**October 11, 2023
7:00 PM
Planning Board Agenda**

Continue review of application for Site Plan Approval and Special Use Permit, personal wireless service facility, 375 Washington Avenue, submitted by Verizon Wireless of the East, LP (dba Verizon Wireless)

This letter is provided in response to the comments raised in the May 8, 2023 memorandum prepared by Mr. John Clarke, with John Clarke Planning and Design. We offer the following responses on behalf of the applicant, Verizon Wireless:

This letter is provided in response to the comments raised in the May 4, 2023 memorandum prepared by Mr. John Russo, P.E. with Lanc & Tully, P.C. We offer the following responses on behalf of the applicant, Verizon Wireless:

SHEET NUMBER
C-1A

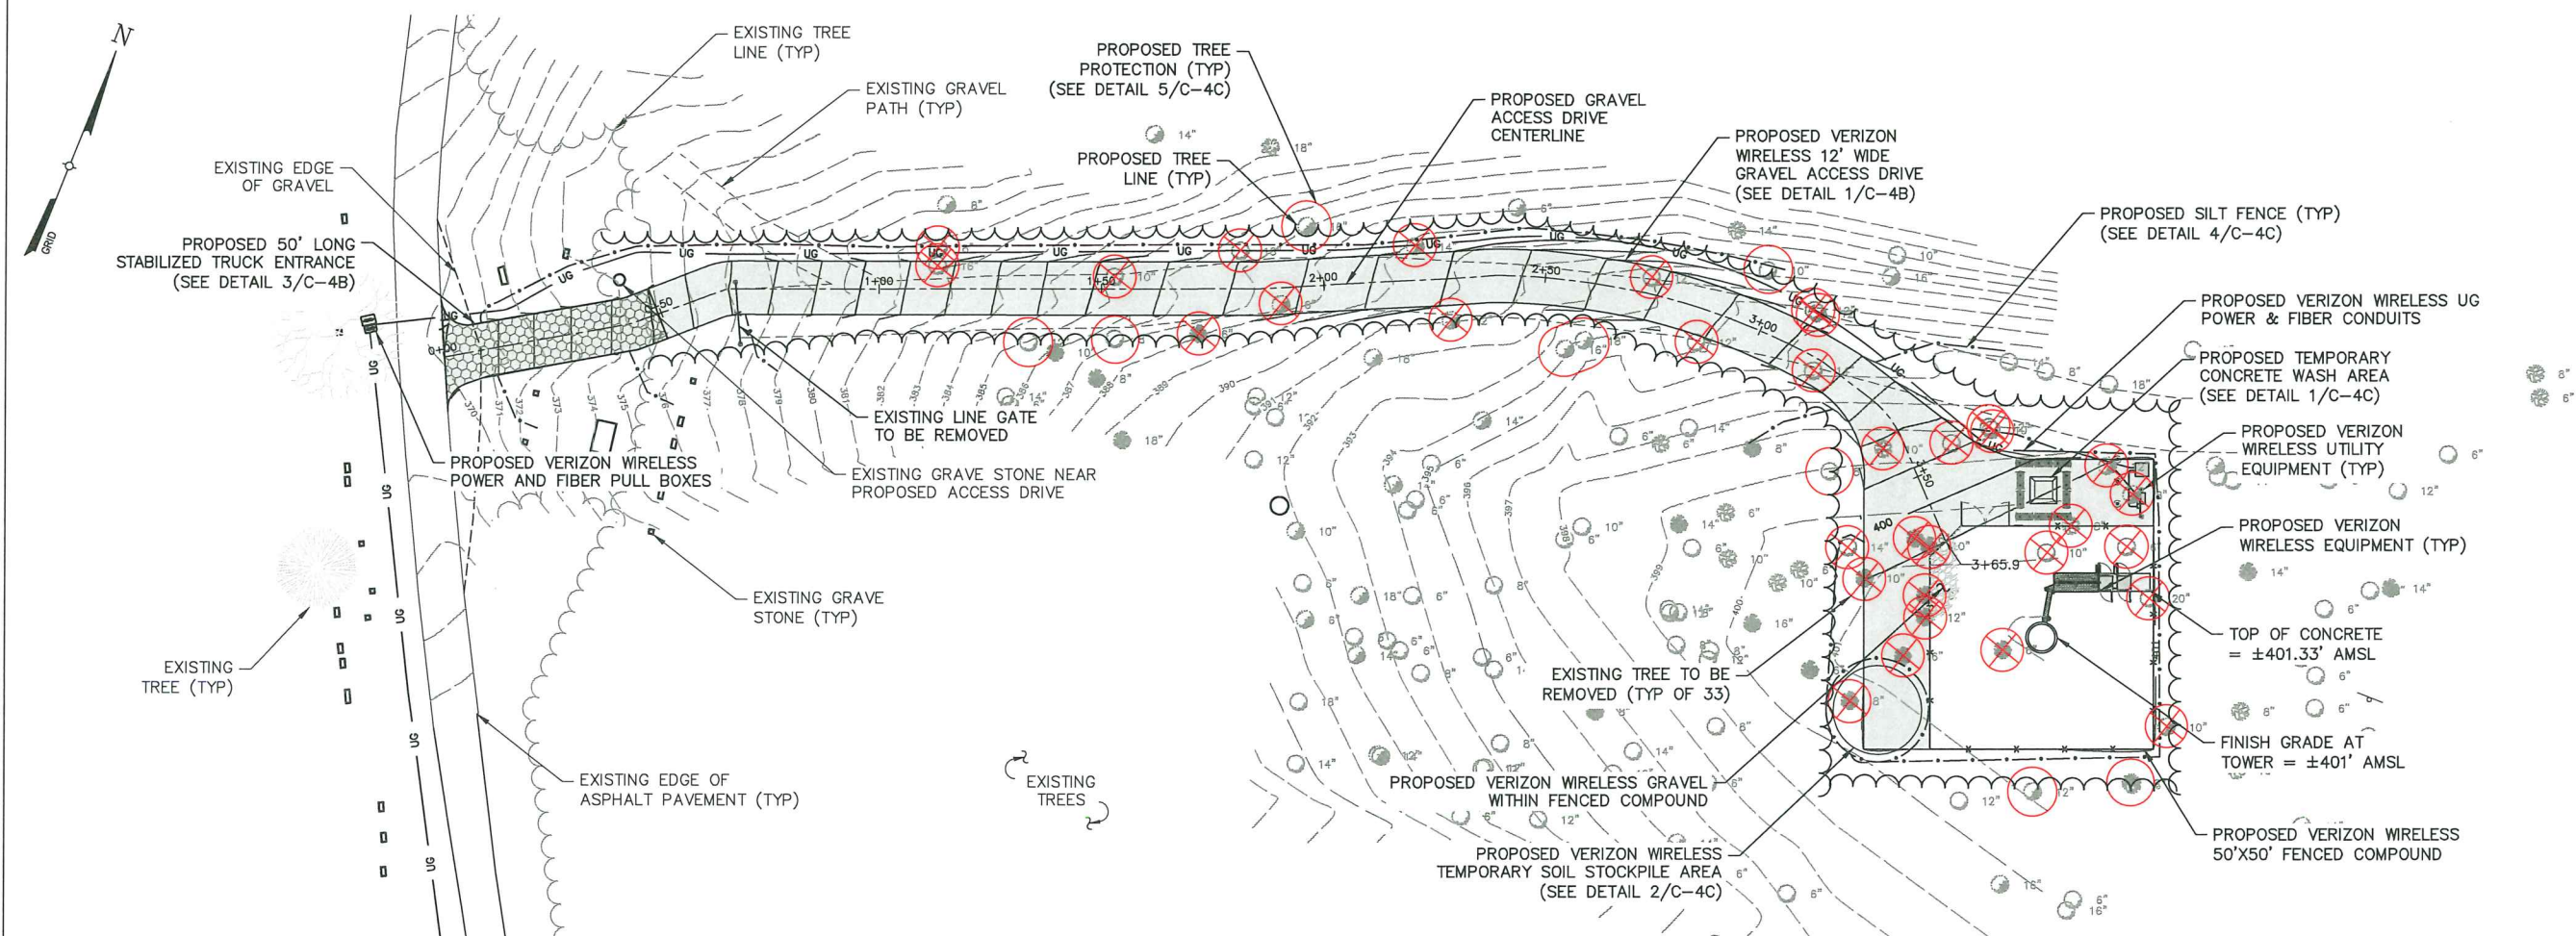
6. As shown on Sheet C-1A, the underground utilities will be crossing the paved drives within the Fairview Cemetery at 4 locations. The plans shall include construction details for the restoration of the pavement.

RESPONSE: Pavement restoration for utility trenching is shown on Detail 3 of Sheet C-4C.

SHEET NUMBER
C-1B

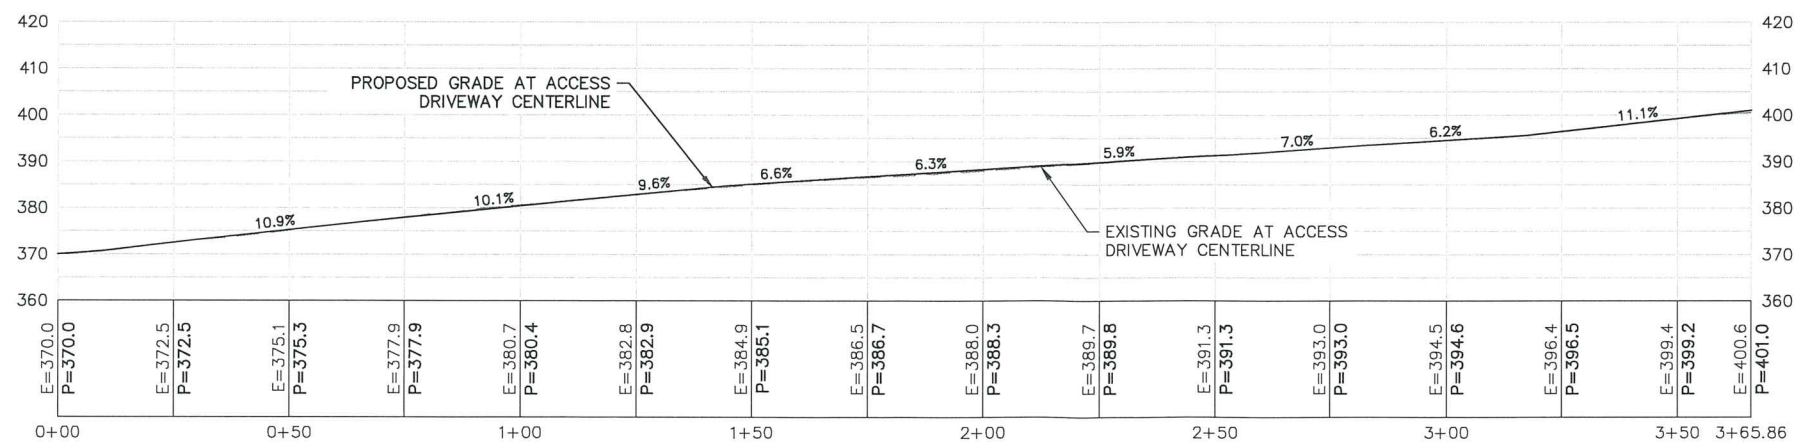
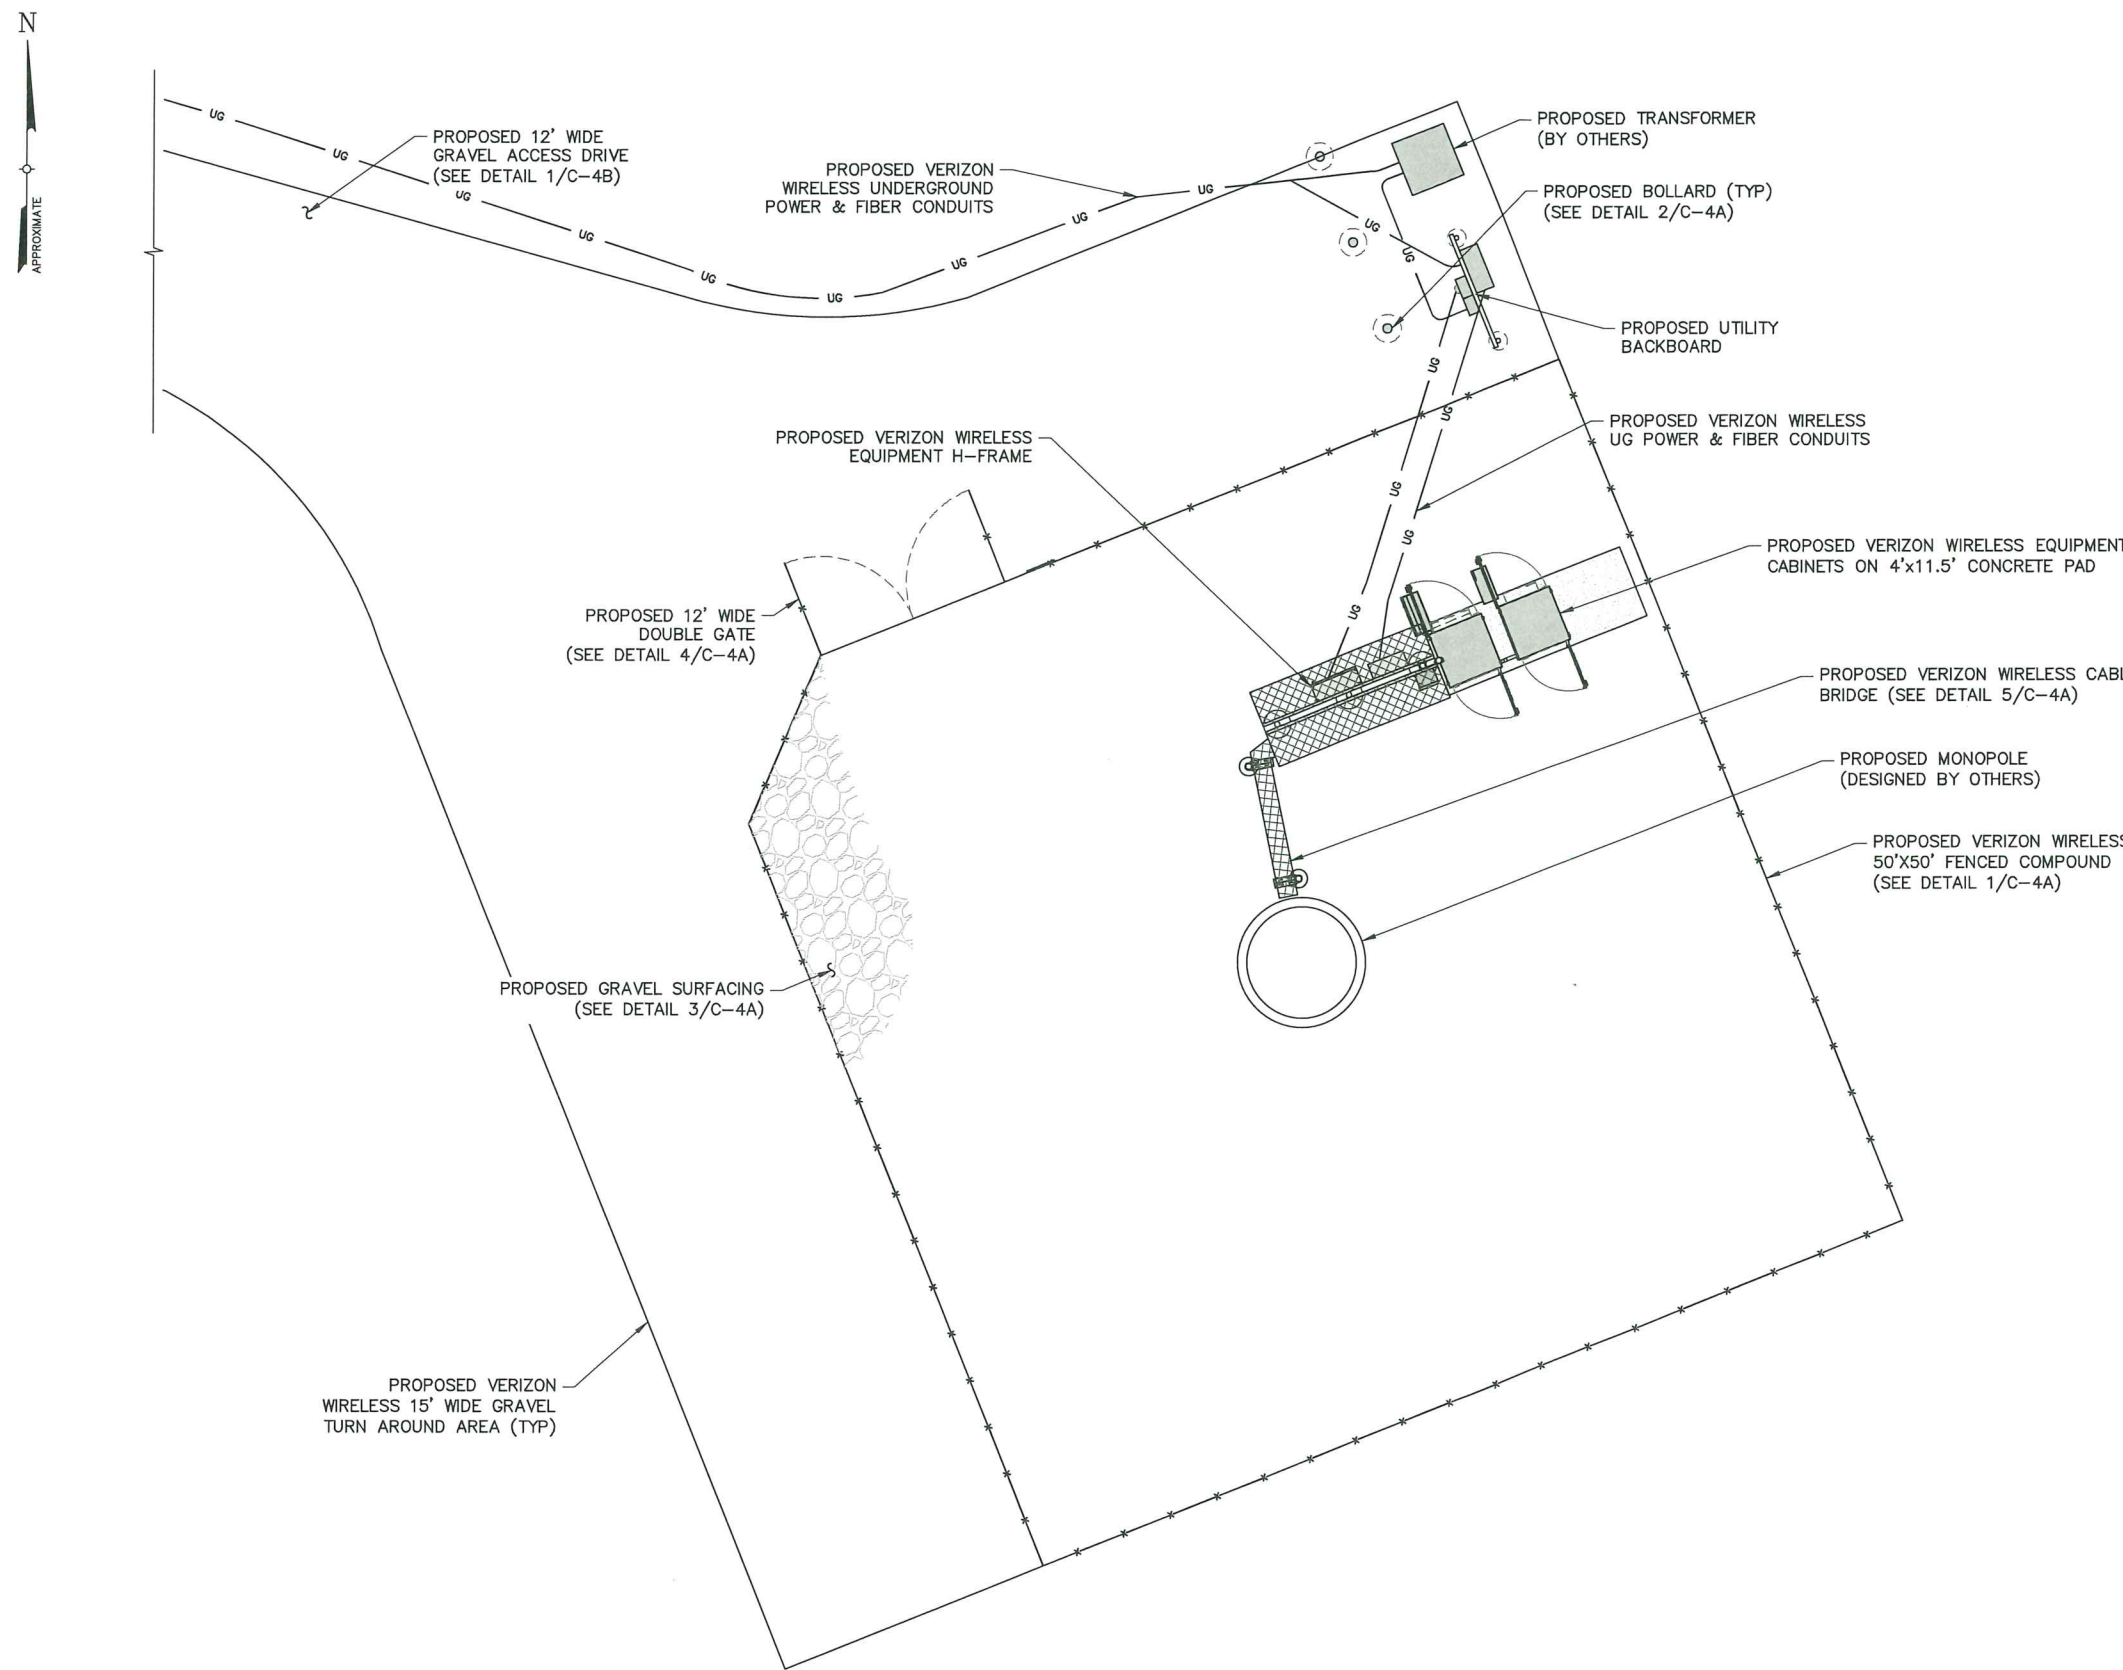
5. The proposed silt fencing along the gravel drive for the project, as shown on Sheet C-1B, should be shifted so that the trenching for the underground utilities is located within the area captured by the silt fence. At present the plans show the silt fencing to run atop or to the inside of this area to be trenched.

RESPONSE: The silt fencing has been corrected as requested. See Sheet C-1B.

C-3

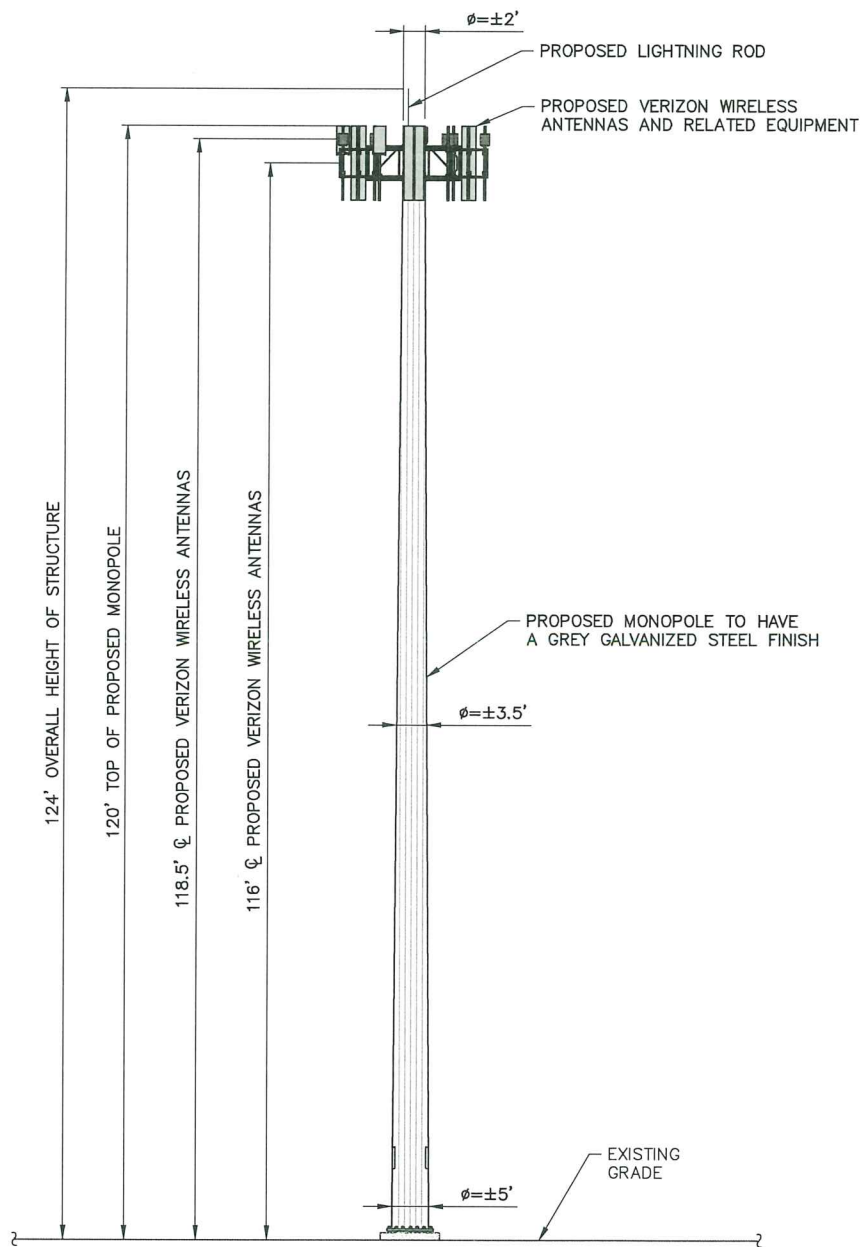
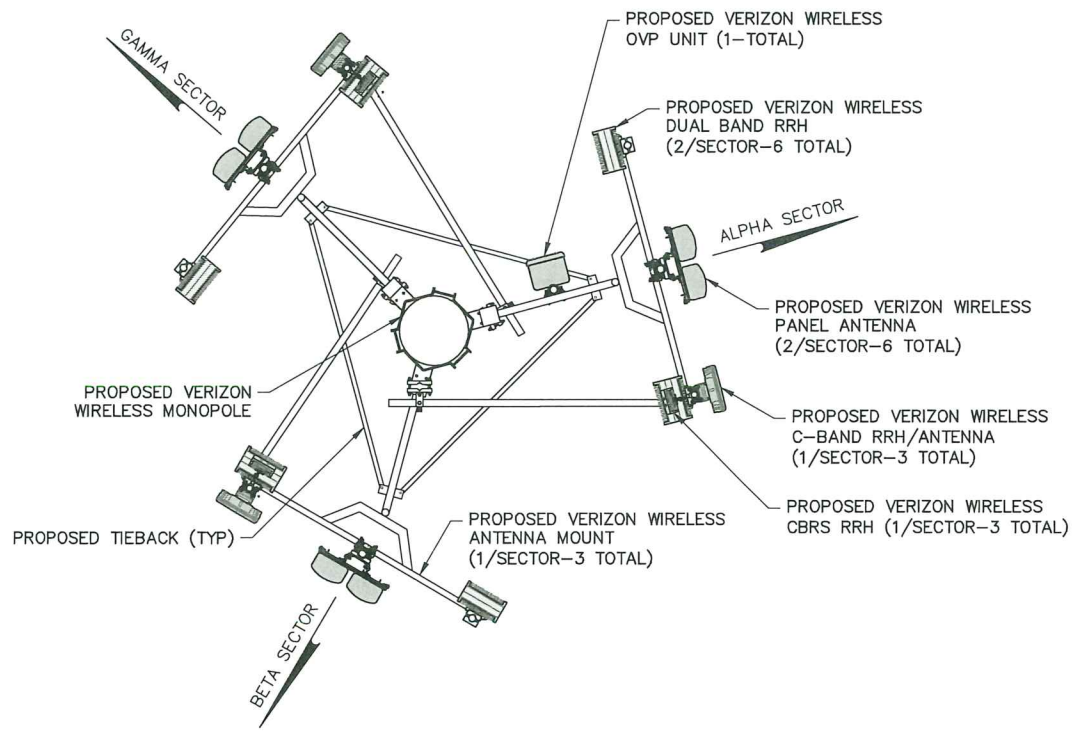
3. The plans should note the varying diameter of the monopole at various heights along its length.

4. The plans shall state the proposed color of the monopole tower.

RESPONSE: Monopole diameters are noted in the site plan drawings on Sheet C-3.

RESPONSE: A note stating the tower will have a galvanized steel finish (gray in color) is shown on Sheet C-3.

3 LIGHTING PLAN
C-4B SCALE: NTS

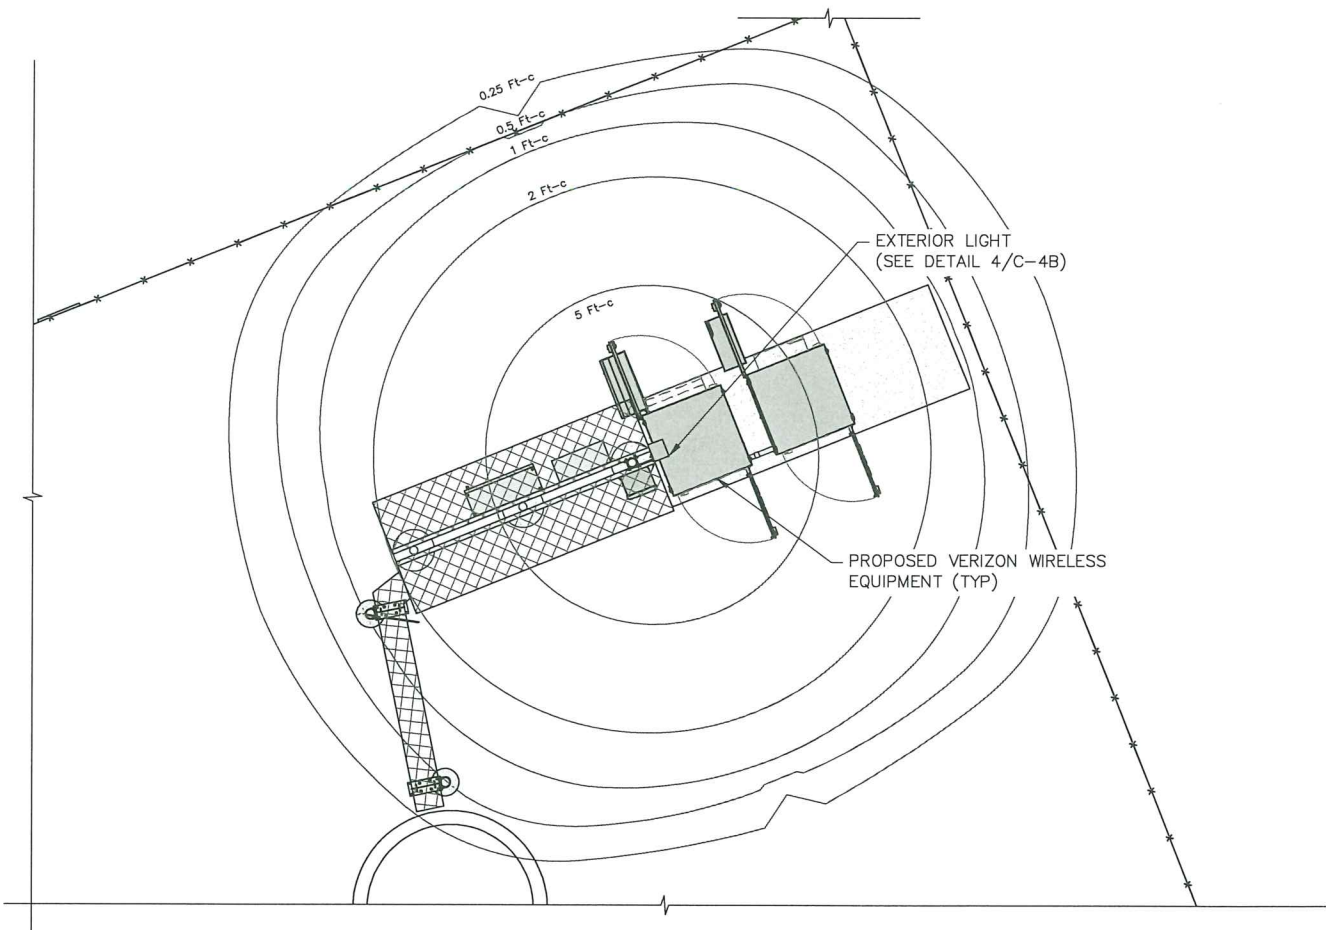
8. Sheet C-4B contains a proposed lighting detail. Note No. 2 for this detail states "Light shall be used by Verizon Wireless technicians during emergency maintenance operations". Note No. 3. states "Light shall be provided with a shut off dial timer." It is unclear as to why the light needs a shut-off dial timer if it is only to be used by technicians during emergency maintenance operations. This should be clarified further.

RESPONSE: The note on Sheet C-4B has been updated. In short, the dial timer is a fail safe that will shut off when the timer expires. This feature is implemented to eliminate the possibility of the technician forgetting to shut the light off when they leave the site, which would keep the light running for weeks or months until the next time a technician visits the site.
